Dalrymple Bay Coal Terminal User Group

2015 Draft Amending Access Undertaking

Submission to the Queensland Competition Authority

24 November 2015

Figure 1 – Simple illustration of monopoly profits produced by DBCTM interpretation

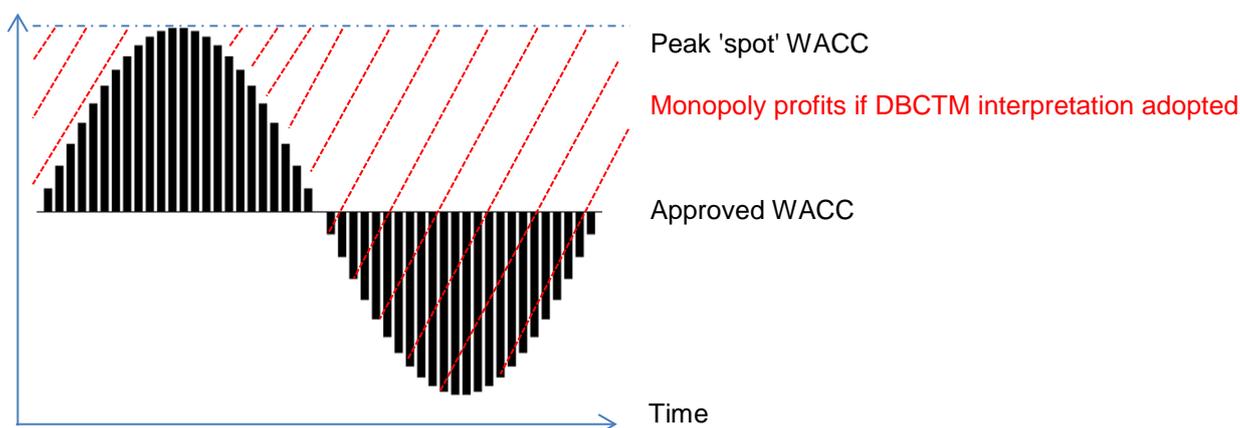
- (iii) as shown in in Figure 1 below, setting access pricing in a way that avoids the risks of the approved WACC being less than any hypothetical spot estimate over the regulatory term would involve setting the WACC at the highest anticipated spot estimate over the term – effectively delivering substantial monopoly profits to DBCTM over the term;

Figure 5 – Indicative TIC Impacts of the DBCTM proposed offsetting pricing parameter changes

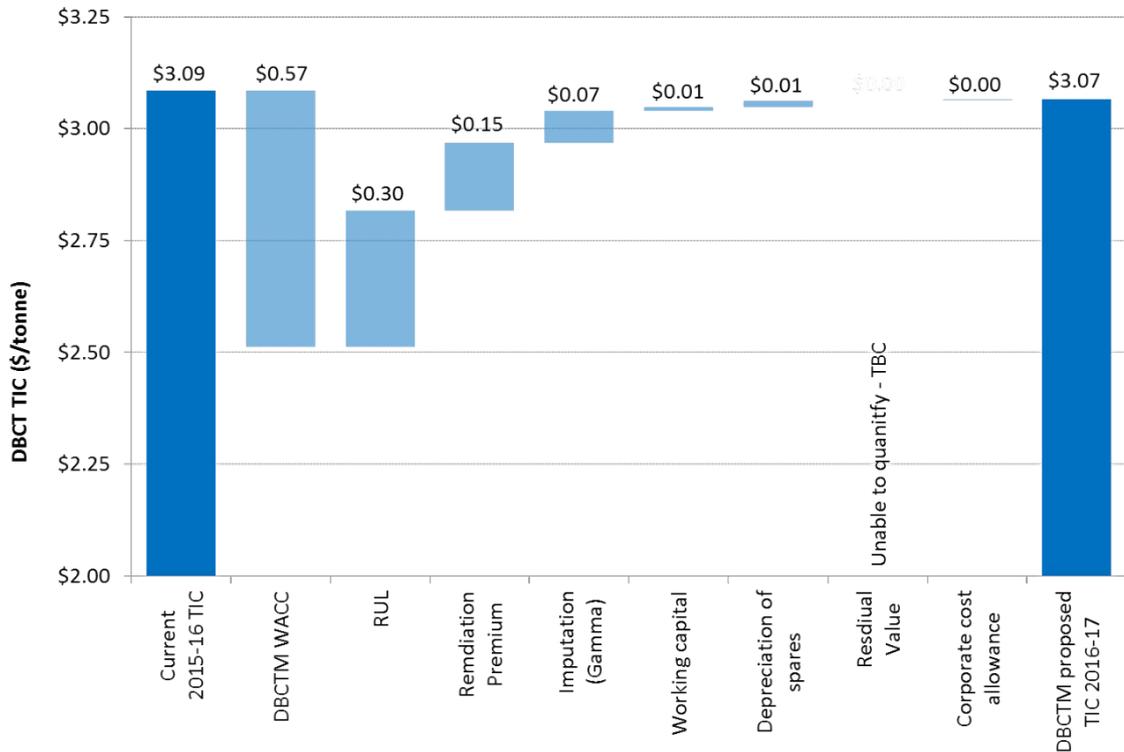
This section seeks to comment and address each of the proposed changes. The DBCT User Group has observed that as a result of submitting a WACC of 7.46% (lower than the existing WACC, due entirely to broader market conditions), DBCTM has proposed offsetting changes to other pricing and calculation parameters such that the level of DBCTM's revenue is protected, at the expense of the DBCT Users. The DBCT User Group is also concerned by the precedent that would be set (in respect of future access undertaking periods when financial market conditions improve), by adopting some of these changes.

The DBCT User Group has analysed the limited available information to assess the impact of each change proposed by DBCTM, as compared to the relevant existing pricing parameter in the current 2010 Access Undertaking. Figure 5 illustrates the impact of the changes that the DBCT User Group has been able to quantify.

The DBCT User Group is concerned that the WACC and other pricing parameters proposed by DBCTM do not reflect the reasonable and efficient cost of providing Terminal services, as required by the QCA Act. This section of the submission considers each of DBCTM's proposed changes and provides an alternative view such that the interests of the DBCT Users and DBCTM are balanced, and the charges Users pay for DBCTM's services reflect reasonable and efficient costs of operating the Terminal.

Figure 6 –Timeline of current and DBCTM proposed RUL

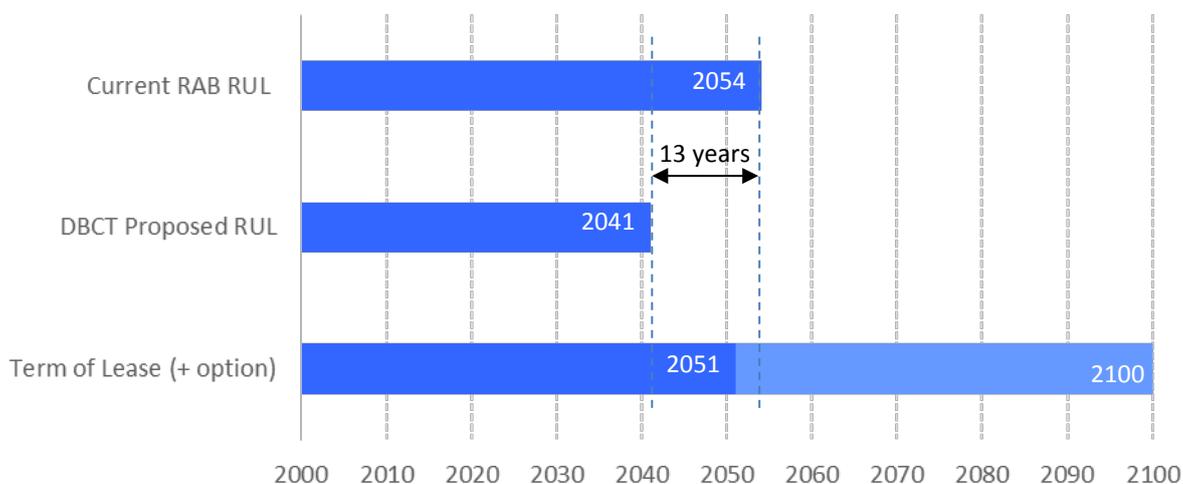
DBCTM has proposed to change the maximum remaining useful life (**RUL**) of its assets to 25 years based on its assessment of a weighted average mine life (**WAML**). DBCTM's proposed change in the RUL has a significant impact on the TIC, increasing it by approximately \$0.31/tonne for FY2017.

DBCTM's key claim to support this change in methodology is that its risk profile has increased. The DBCT User Group disputes this claim given the evidence provided in Section 3.2 suggests the outlook for the Australian coal export market remains strong and continues to grow, despite short term market conditions.

The DBCT User Group also notes that previous QCA decisions provide a clear precedent for determining the RUL. The end of the economic life of the terminal, 50 years from 1 July 2004, was considered by the QCA to be appropriate for the maximum depreciation life of the terminal assets. Figure 6, shown below, illustrates that DBCTM is proposing to reduce that maximum RUL by 13 years.

Figure 7 – DBCT User Group view of indicative 2016-17 TIC

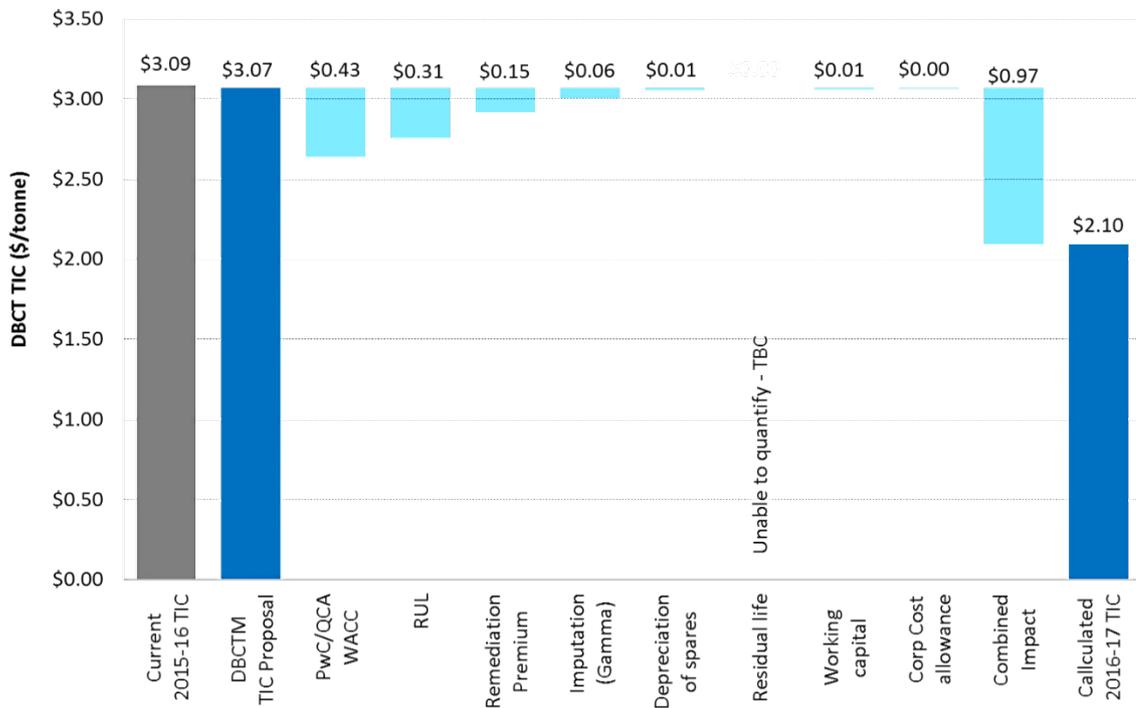
The DBCT User Group has assessed the combined impact of all of the preceding adjustments, with this analysis shown in the figure below. It includes:

- (i) the DBCT User Group-determined pricing parameters as advised by PwC (i.e. WACC);
- (ii) adjustments to the DBCTM proposed parameter where the QCA position is clearly established; and
- (iii) excluding/reversing pricing parameters adopted by DBCTM in its submission that require the QCA to approve a DBCT-specific change in methodology for the 2016-2021 access undertaking period.

The WACC parameter has the largest single effect on DBCTM's allowable revenue and resulting TIC. Since DBCTM does not have a significant operational or maintenance role at DBCT, the return on assets component of the building block calculation accounts for more than two-thirds (based on DBCTM's submission) of the total allowable revenue. In contrast, Aurizon's allowable revenue includes significant operations and maintenance costs and as such the return on assets component accounts for less than 40%⁴⁴ of the total allowable revenue. This means that the impact of a reduction in WACC for DBCTM is amplified when presented as a percentage change in allowable revenue and/or TIC, as compared to other regulated infrastructure providers.
